741 FISGARD ST. DP & REZONING

Revisions
Bubbled areas indicate revisions compared to the previously submitted plans

Development Permit / Rezoning Application

741 Fisgard Street
March 30, 2026

sheet title
Landscape Materials - L2 and L4 Amenity

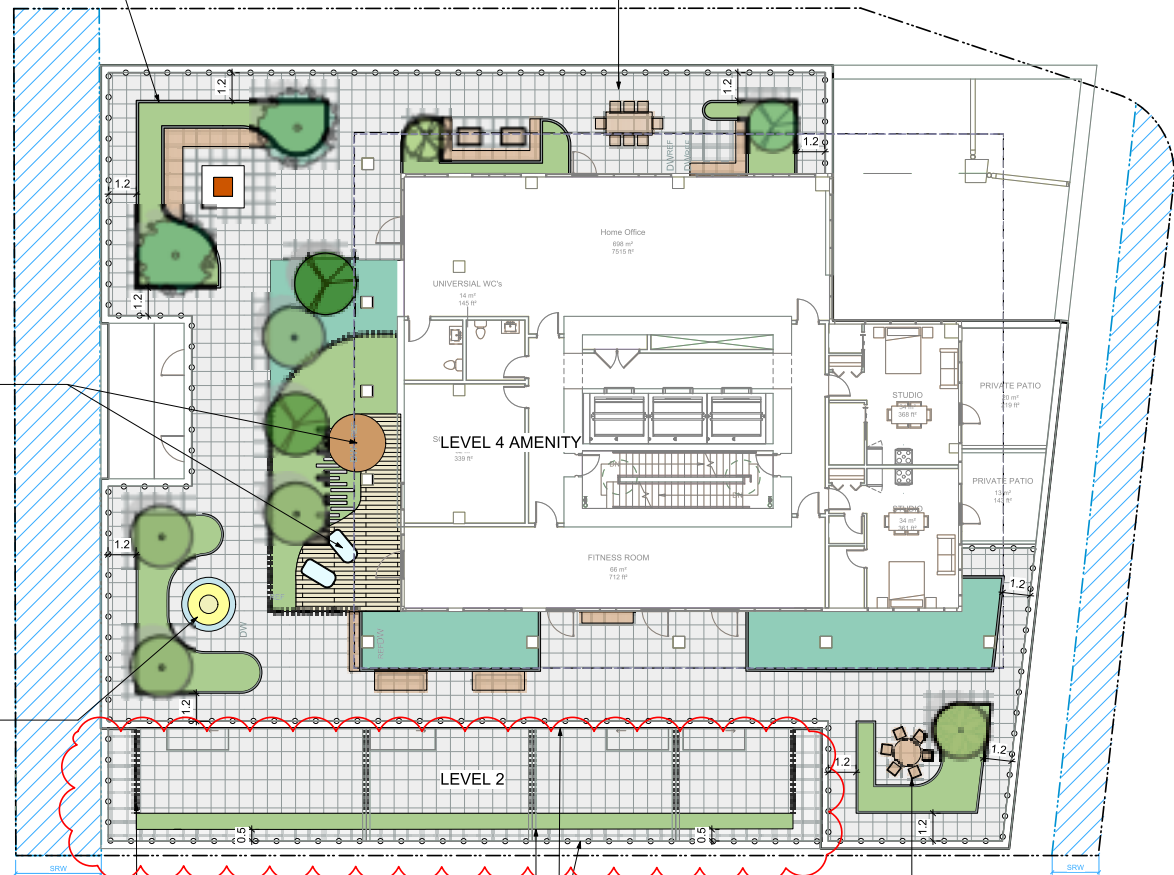
CHANGES TO PLANTING - PLANTER ADDED AS PER REQUEST FROM ADP FOR BALCONY SCREENING. PLANTER WILL BE GUARD RAIL HEIGHT.

Planter to be 1070 mm to match BCBC guard rail height requirements.
